Supplemental Type Certificate

Number SH7979SW

Installation of a nose mounted FLIR 2000 A/B Imager, in accordance with Premier Drawing B32-13002, Revision D, dated 3/7/95, or later FAA approved revision.

FLIR INSTALLATION

8 of

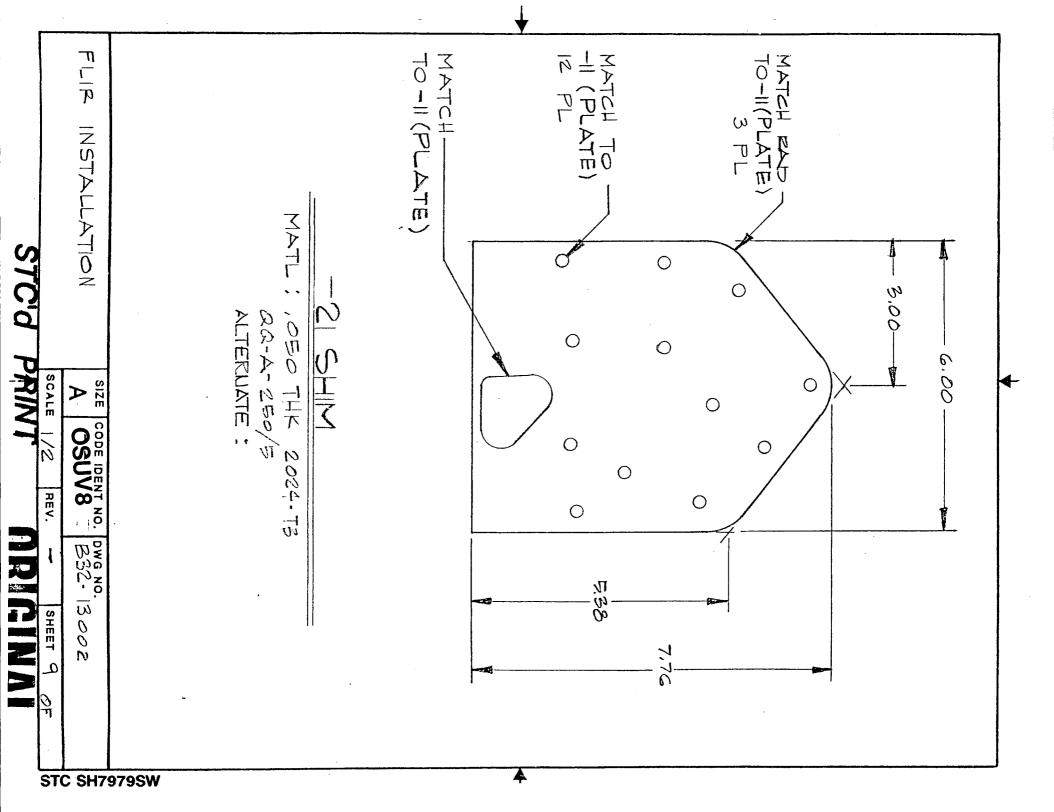
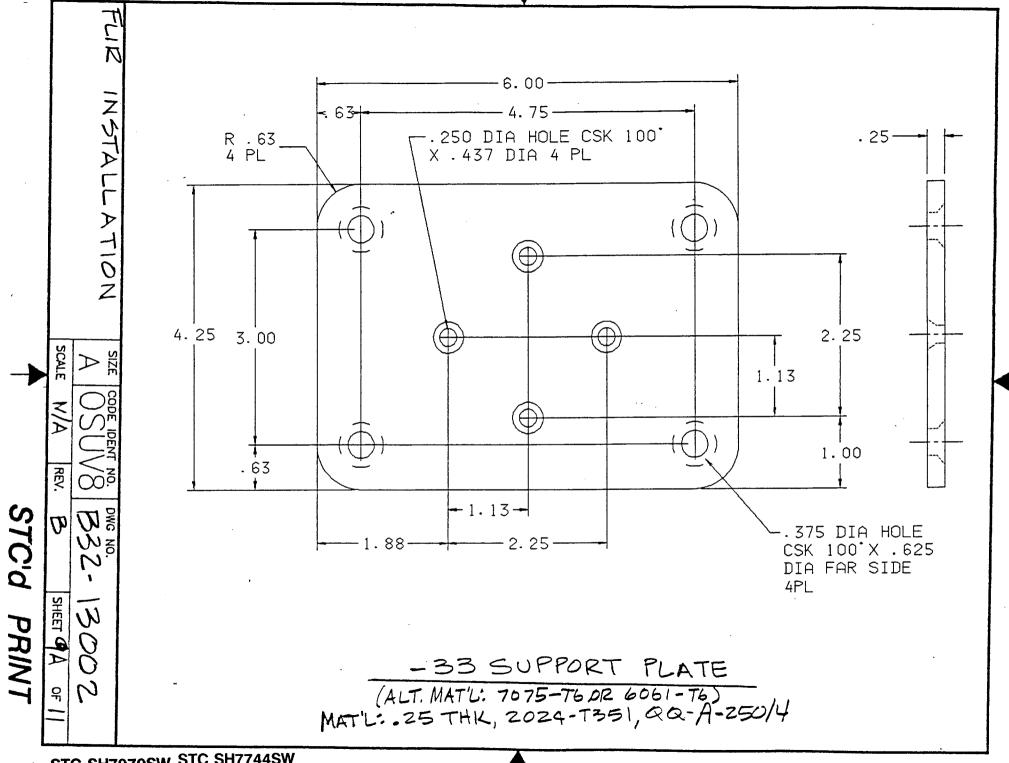
SHEET 8 — CHANGE MATL, OF CHANGE HORIZONT	13 PLATE FRUM TAL DIMENSION 1.		. UU THK.	
IMPACT YES NO	PROCUREMENT	PRIORITY CH	HANGE CLASSIFICA	TION
INTERCHANGEABILITY ■ □ DRAWING CHANGE □ ■	ACTION YES NO	1	■ RECORD A MAJOR □ TSO M	1AJOR
SPECIFICATION SPARES		5 🖬	A MINOR TSO M	
PREPARED BY DATE PROJECT	ENG DATE C	DA . / J	TE FAA SUBMIT	TAL
